Re: **Rialto Village**

MDP # 026A-06/ PUD # 06-019A

The Development Review Committee has reviewed **Rialto Village** Master Development Plan **MDP # 026A-06/ PUD # 06-019A**. Please find enclosed an accepted and signed copy for your files.

RIALTO VILLAGE
 MASTER DEVELOPMENT PLAN/PLANNED UNIT DEVELOPMENT
 MDP # 026A-06 PUD # 06-019A

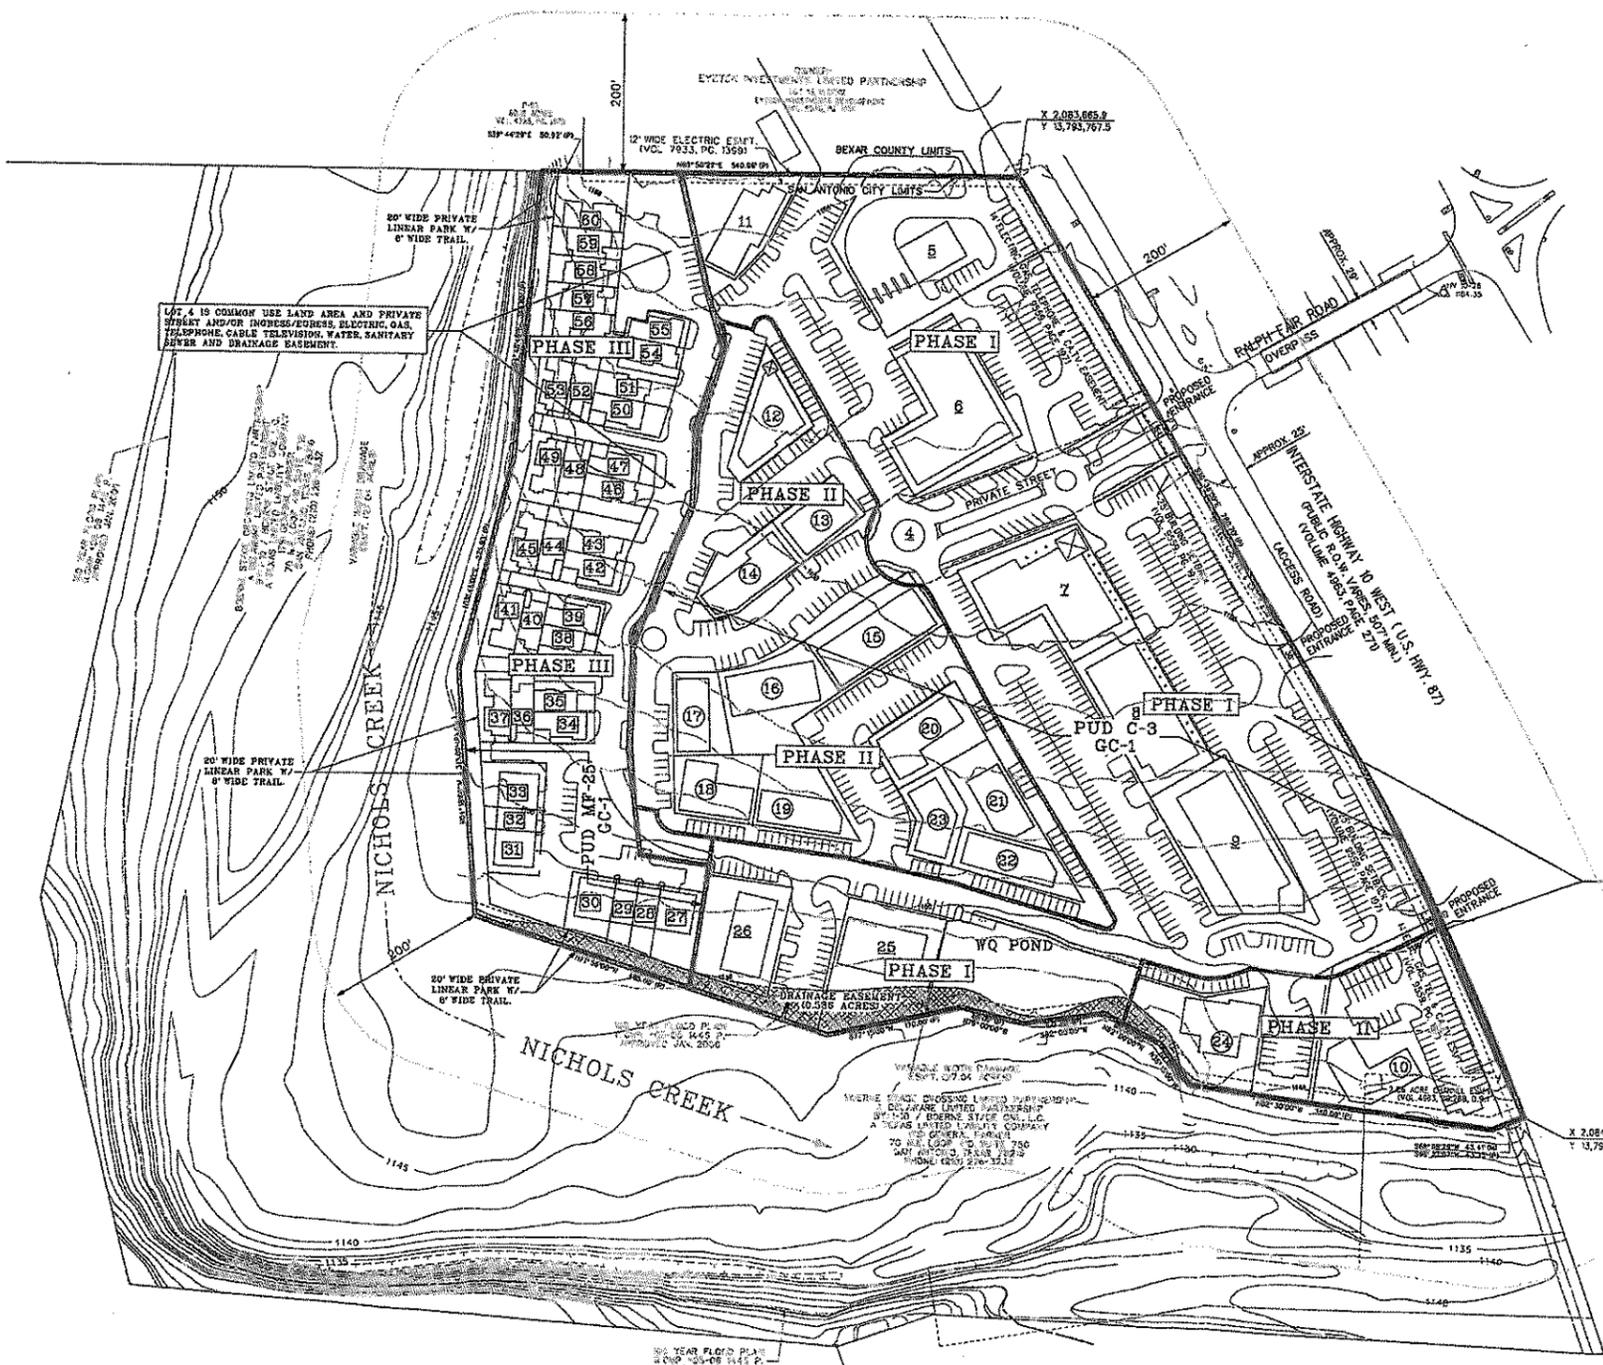
Parks and Recreation Department approves with the following conditions:
Rialto Village is a proposed subdivision with 132 multi-family residential units. UDC Section 35-503, Table 503-1 states that multi-family development is required to provide 1 acre of park/open space per every 114 dwelling units. The requirement for this development is 1.2 acres. This subdivision provides 1.5 credit acres of parkland dedication by providing a minimum 1/4 mile walking trail per UDC Section 35-503(h) *Credit for Park Facilities*.

- The parkland provided shall be shown as "Park" or "Open Space" on a plat; UDC sections 35-503(e) *Designation of Parkland*.
- The parkland provided is dedicated to the Home Owners Association.
- The instruments creating the Home Owners Association are provided by the second application for plat approval; UDC sections 35-503(e) *Designation of Parkland*.

- Parkland dedication must be platted by the second phase of residential development; UDC section 35-503(f) *Development Phasing*.
